Bowdens Proposal: Hydrogeology

IPC 15 Feb 2023

Lue Action Group

Review of Bowden's Response to Groundwater Questions: Bowdens' March 2022 Amendment Report

Figure 3: SW-NE Cross Section Source: GoogleEarth 2022

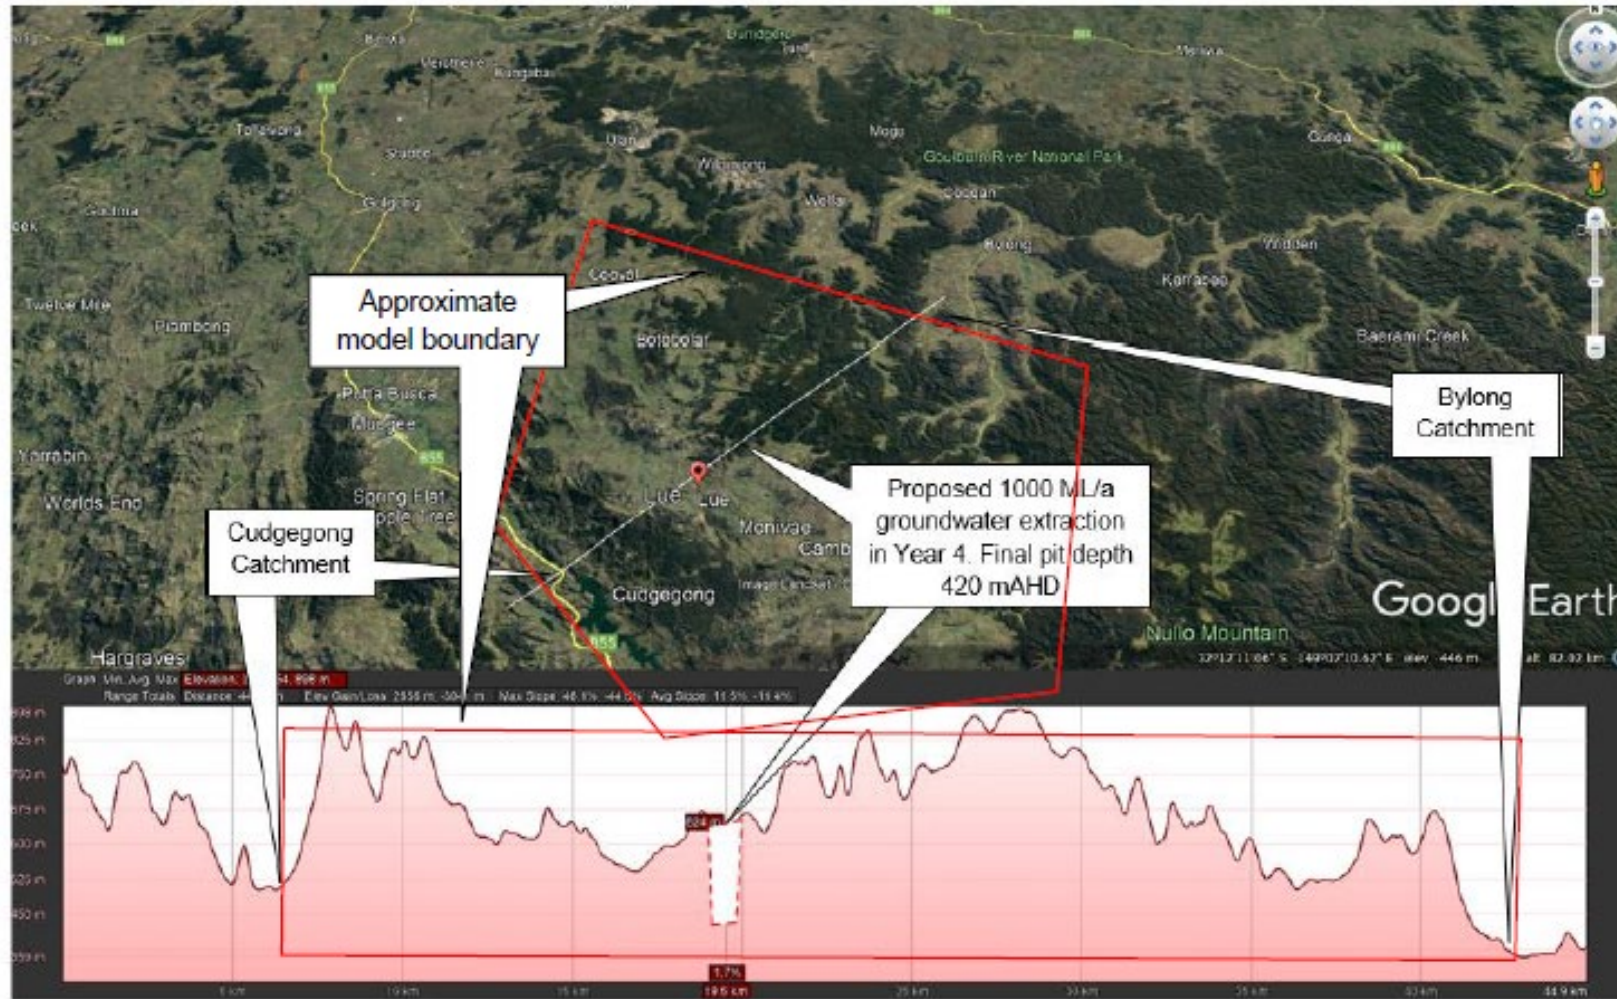
40 m in Context: potential to alter regional hydrology

NW-SE Section during proposed dewatering – showing potential GDEs

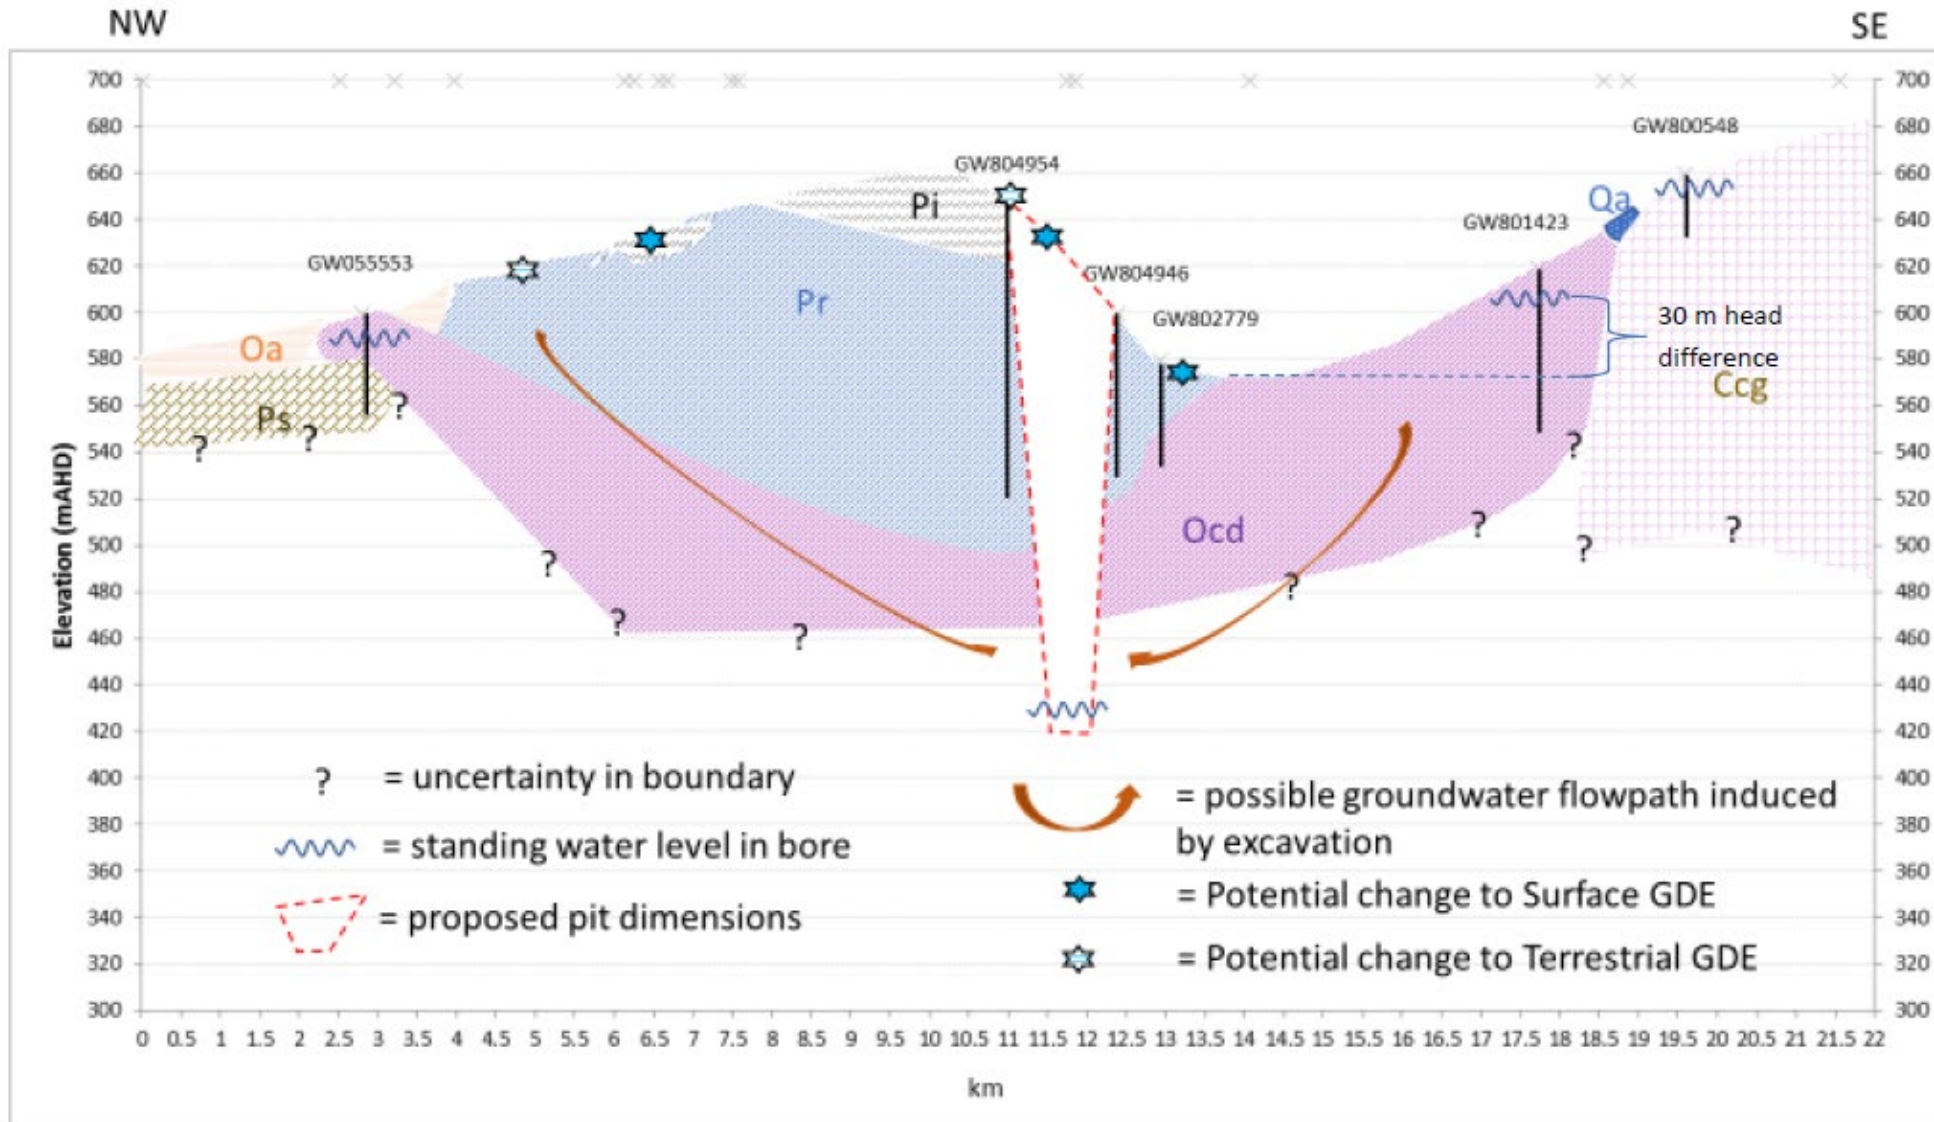
‘no water quality impacts beyond 40 m from the Mine Site boundary and no changes to the beneficial uses of aquifers are predicted’

Source: LAG report by Australian Water Environments (2018) indicating water salinity and regional impact

Figure 4: Site Geology, adapted from (R.W. Corkery & Co., March 2022c, pp. 2-10)

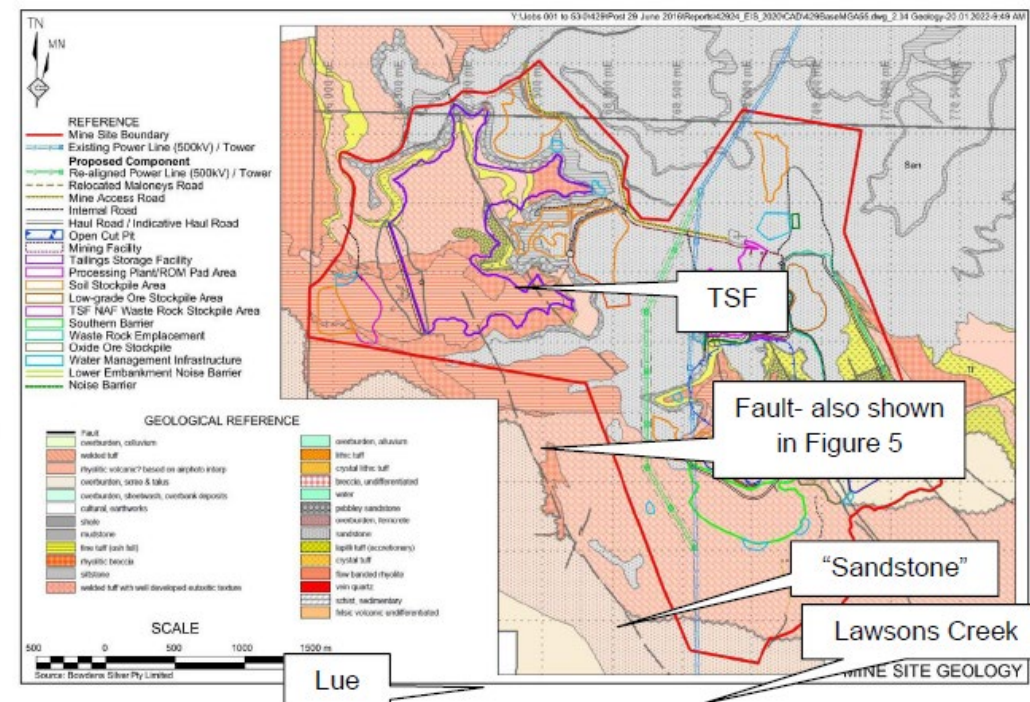
1. R.W. Corkery & Co. A4 (Feb 2022): enhanced permeability within fractured rock aquifers near major geological structures

1. AIP 14: there is potential for causing and enhancing hydraulic connections that has not been clearly presented.
2. AIP Table 4: potential unquantified water quality impacts on nearby licensed groundwater users

Figure 35 Predicted Drawdown at End of Mining (Year 15.5)

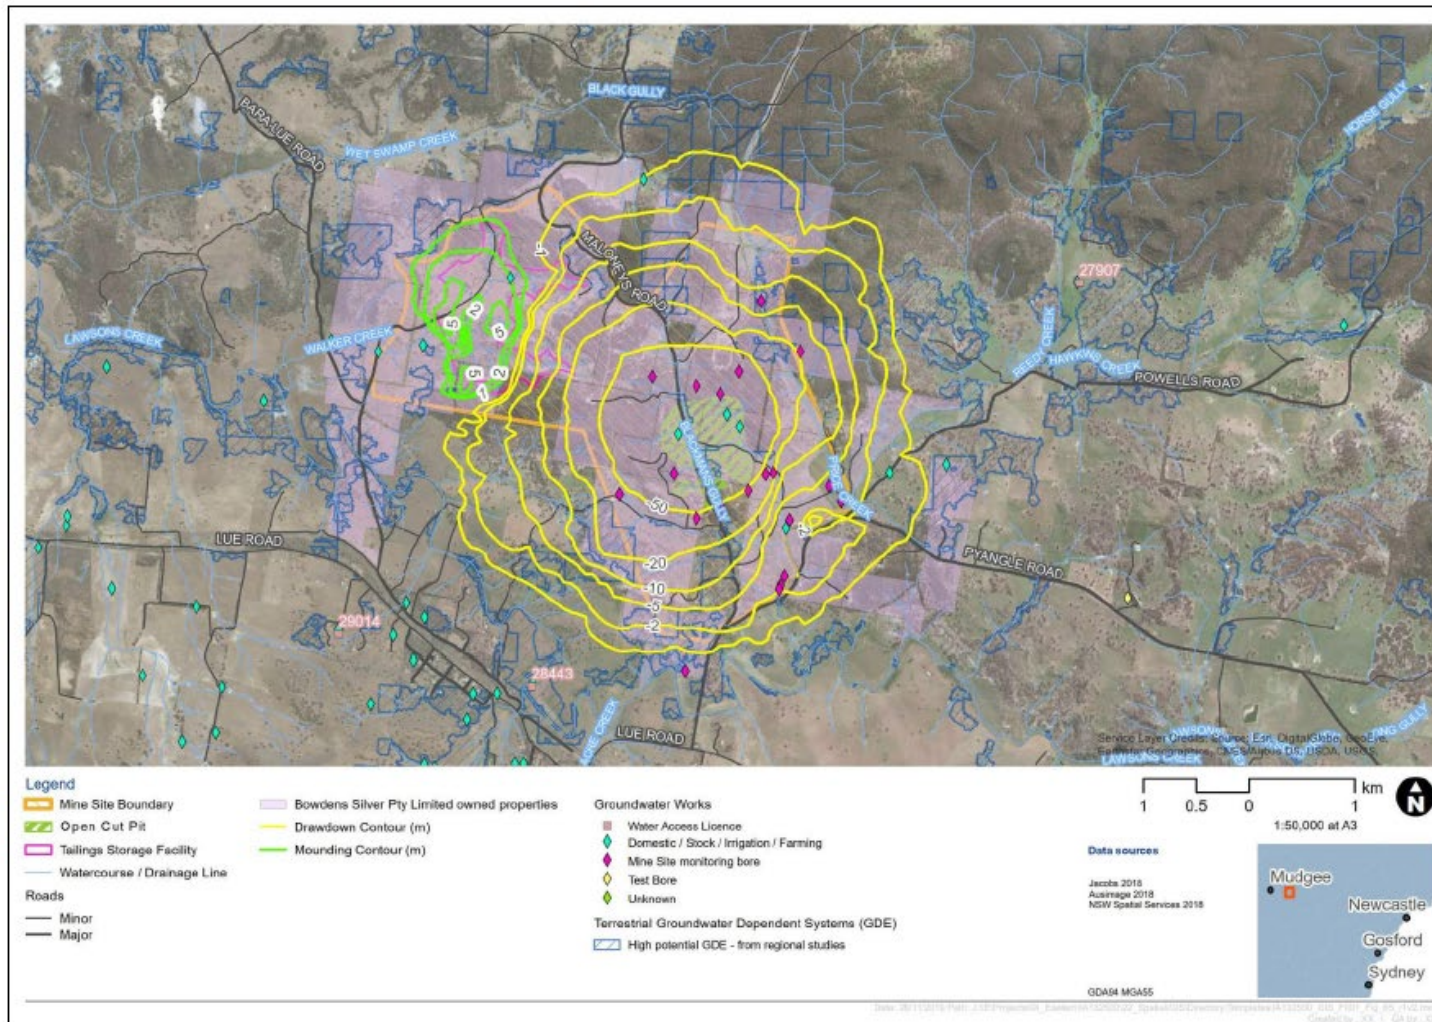
1. The post mining groundwater flows are **unlikely** to be towards the pit (R.W.Corkery & Co. Dec 2022 & HydroGeoLogic Dec 2022)
2. Significant and unexplained alterations to model Layer 1 and 2 were made around the TSF in 2022 (HydroGeoLogic 2022)

Figure 6: Modelled thickness of combined Layers 1 and 2

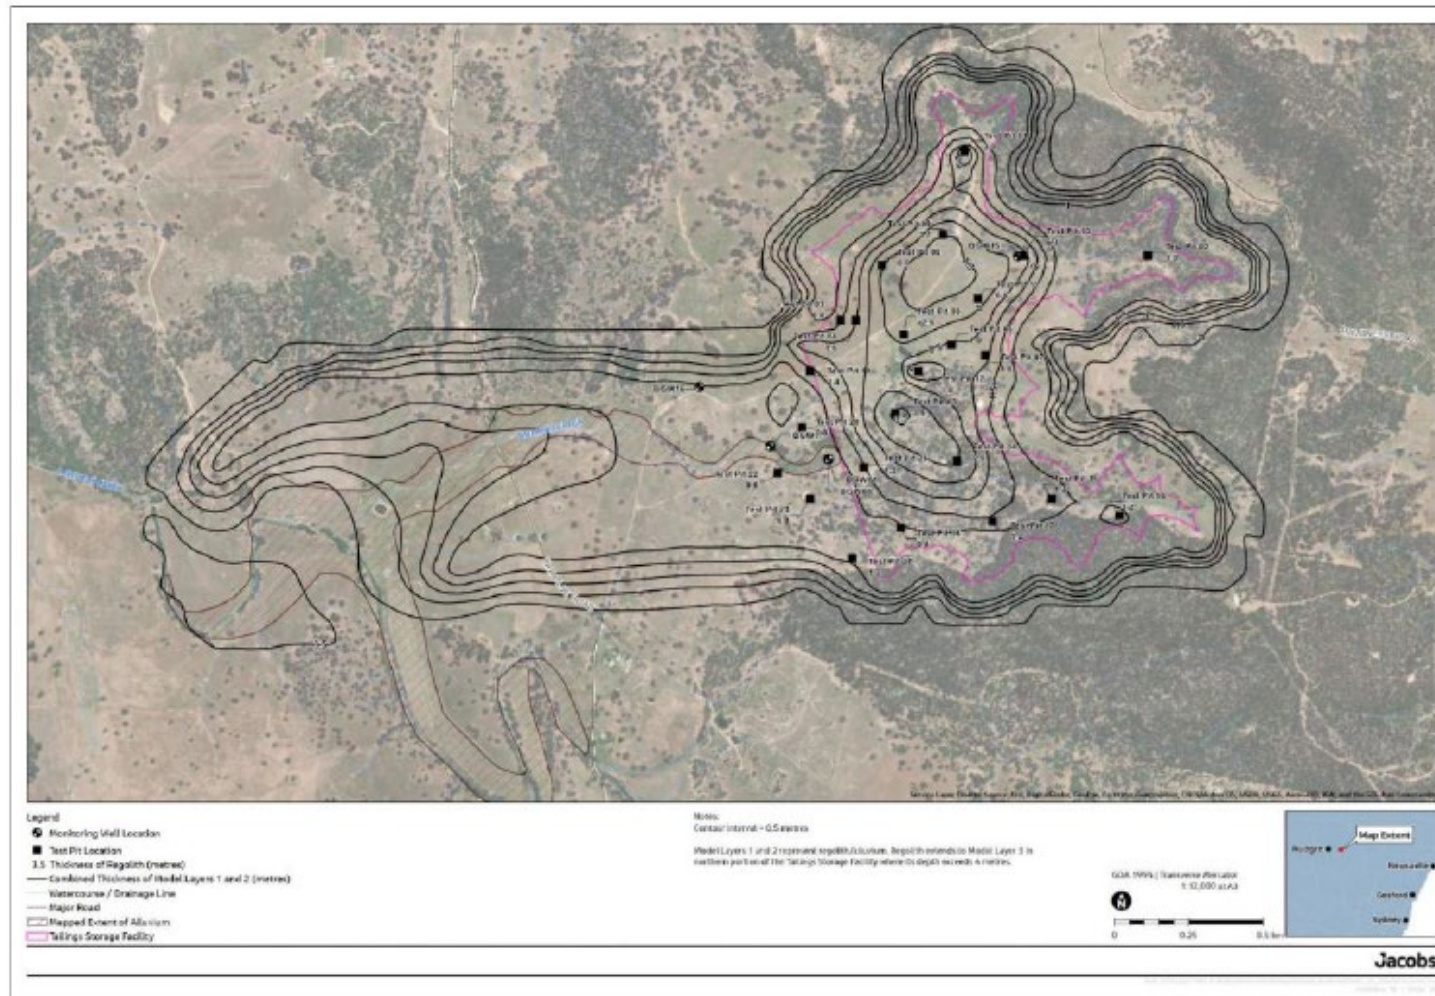
Hydrogeological Model Relayering for 2022

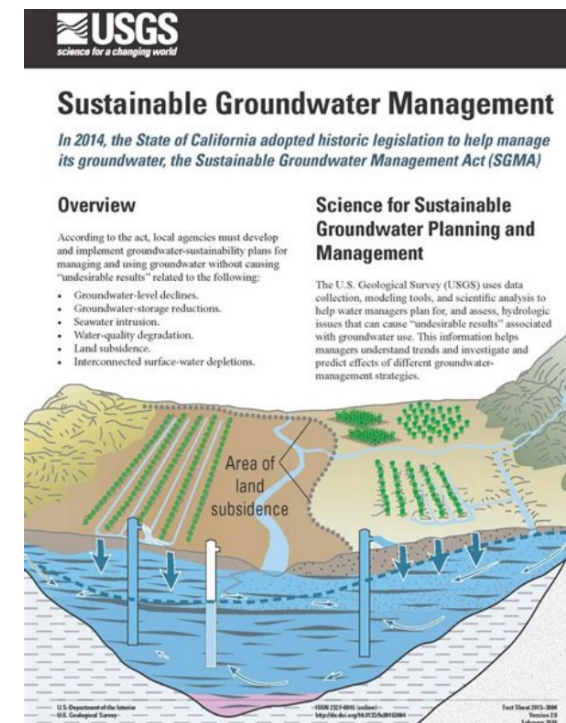
1. Investigating significant groundwater dependent ecosystems would enable an effective monitoring plan.
2. No locations, quantities, controls or triggers for monitoring bores are provided (R. W. Corkery & Co., 2022d, pp. 5-149),
4. A peer reviewed AS/NZS ISO 31000:2009 Risk Assessment would assist

The likelihood of contamination from the final void lake warrants a source-pathway-receptor assessment

Figure 1: Water source inflows (R. W. Corkery & Co., March 2022b, p. 20)

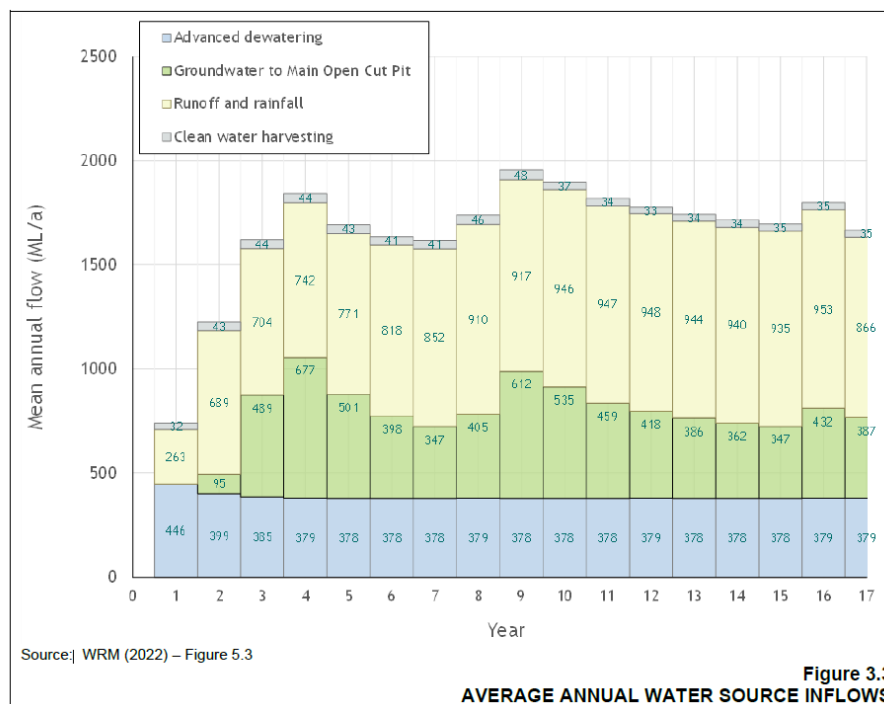
Over 1,000 ML/a of groundwater is expected to be harvested in Year 4. Figure 1 indicates that groundwater yields are not expected to change as open cut pit inflow rates change.

If no hydraulic barrier is modelled between the production bores and the pit, this implies capture and drainage of groundwater recharge over a large area such as the Cudgegong catchment - Figure 3 – or upstream in the Lawsons Creek Catchment. This water would otherwise report to other groundwater users. An updated water model balance (Table 2) provides useful data on where water enters and leaves the groundwater model (bounded by the red polygon in Figure 3). Production from “well” cells in the model is 1,816 ML/a and more work is required to determine how much is from bores within the site water balance.

Figure 2: Biodiversity Study Area - does not extend to Lawsons Creek south of the site in R.W. Corkery & Co. 2022 Appendix 5 (EnviroKey) March 2022.

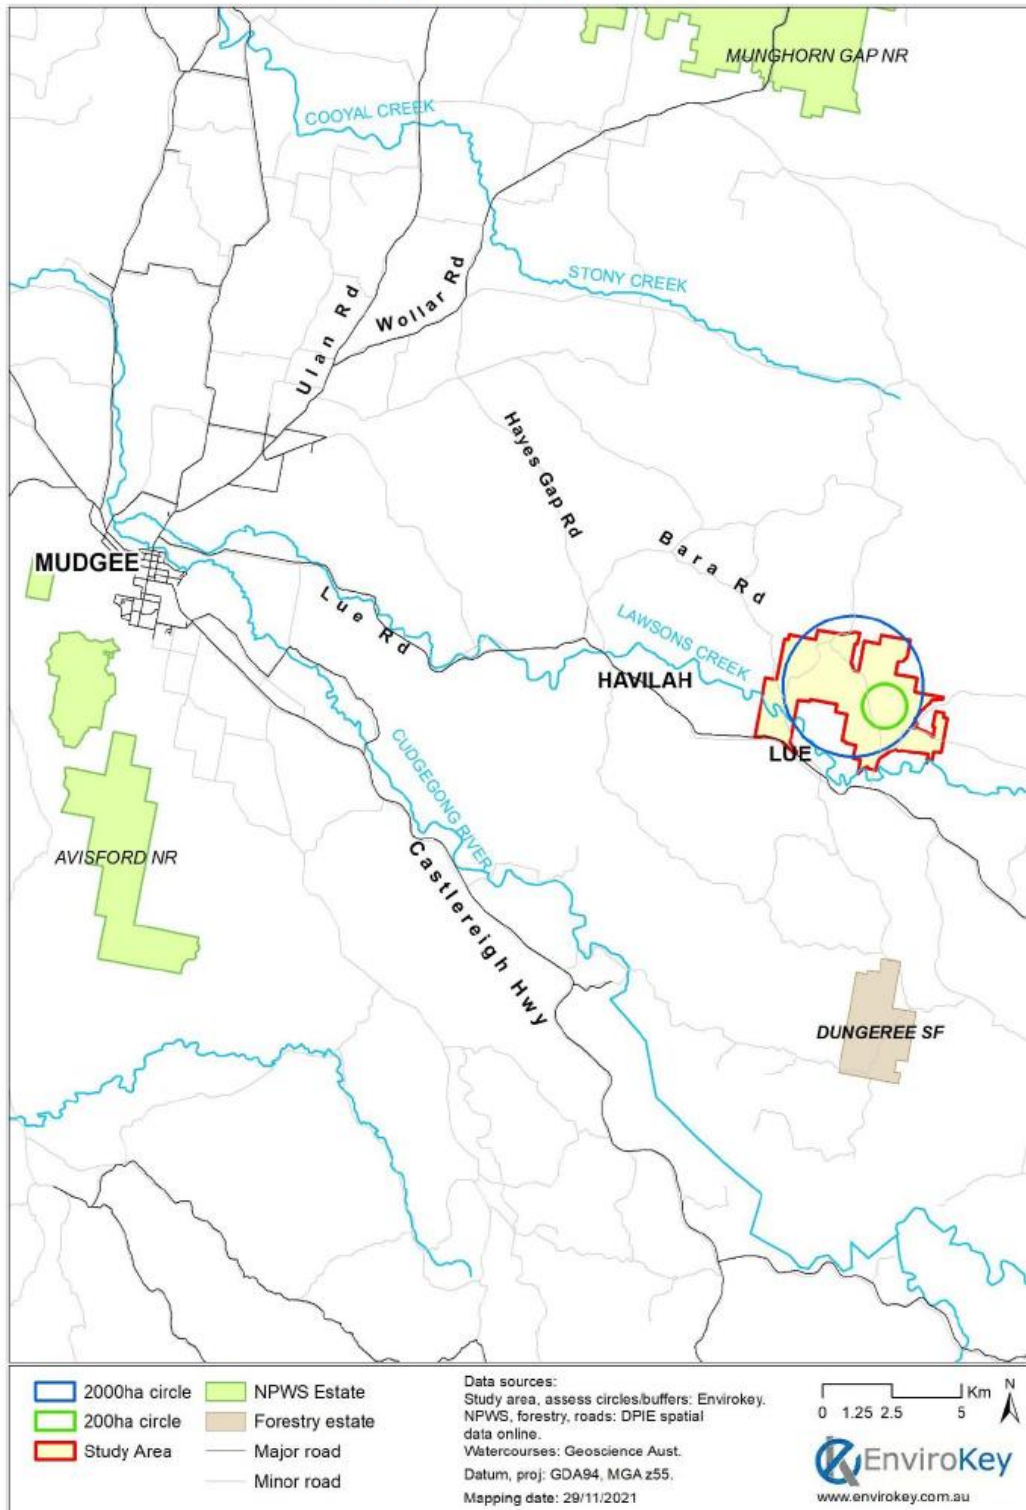
Volume 3 Part 9A – Biodiversity Assessment was updated in March 2022, however, EnviroKey were not advised that proposed disturbances might extend beyond previously surveyed areas due to the increased groundwater extraction proposed. In other reports, a permanent reduction in streamflows around the site due to reduction of rainfall run-off and a reduction in baseflow from groundwater is predicted (R.W. Corkery & Co., March 2022c, pp. ES-24). The disturbance is thus beyond the Study Area EnviroKey has been directed to consider (Figure 2).
